### REMARKS

**In the Drawings:**

FIG. 14

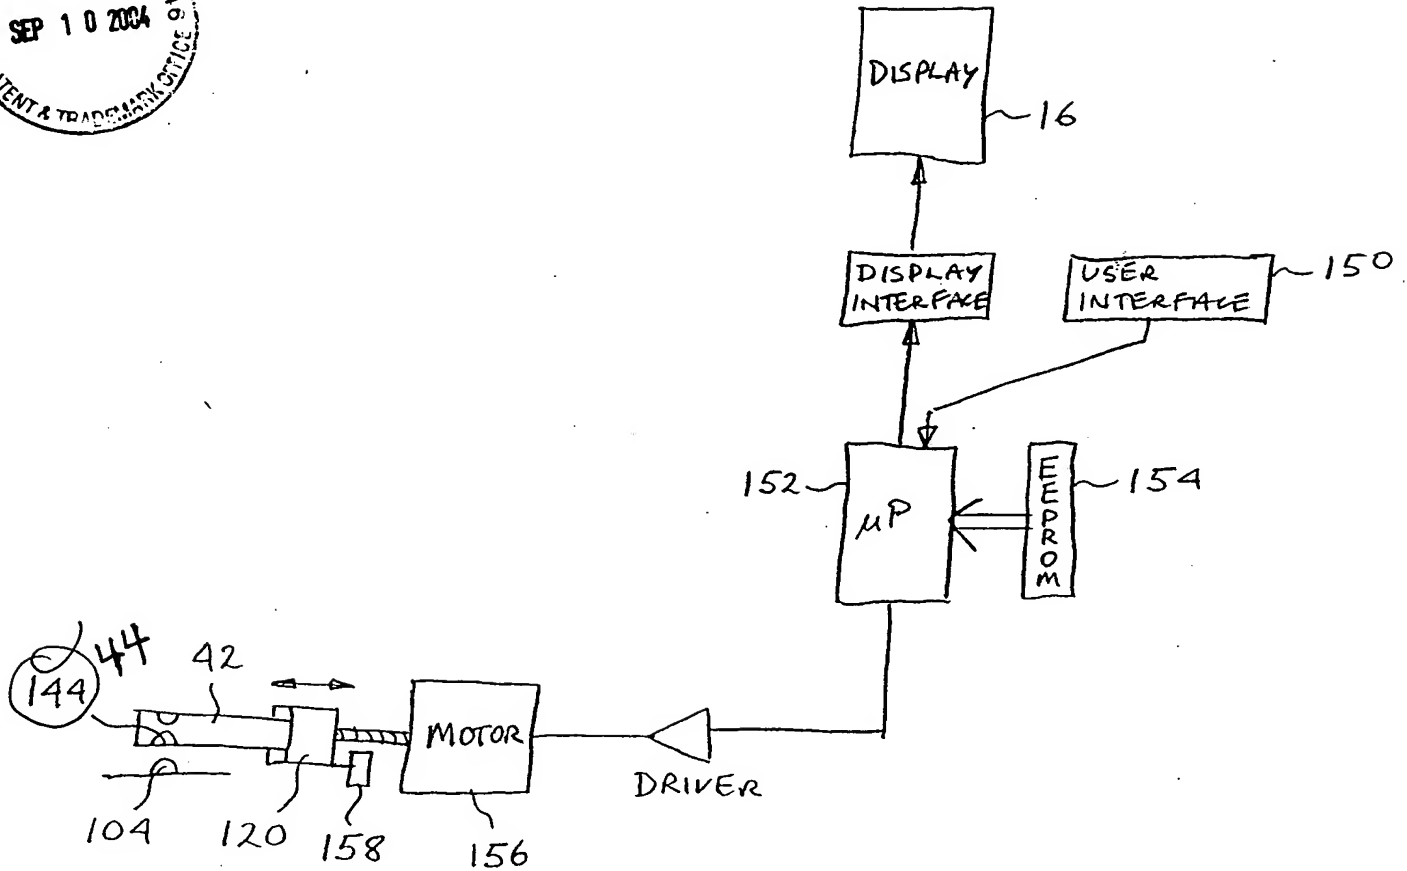
The drawing of Figure 14 has been amended to correct an obvious oversight as to the appearance of a reference number 144 in original Figure 14, instead of a reference number 44, as reflected in the new drawing of Figure 14. As amended, the drawing of Figure 14 is consistent with the specification, for example, paragraph [0077] of the specification, and the drawings of Figures 2 and 9A. No new matter has been added by virtue of this amendment.

The attached replacement sheet includes Figure 14, as changed, and Figure 15, as originally filed. This replacement sheet that includes Figures 14 and 15 replaces the original sheet that includes Figures 14 and 15. The attached annotated sheet is marked to show the change made. The change in Figure 14 is also reflected in the previously submitted formal drawings.
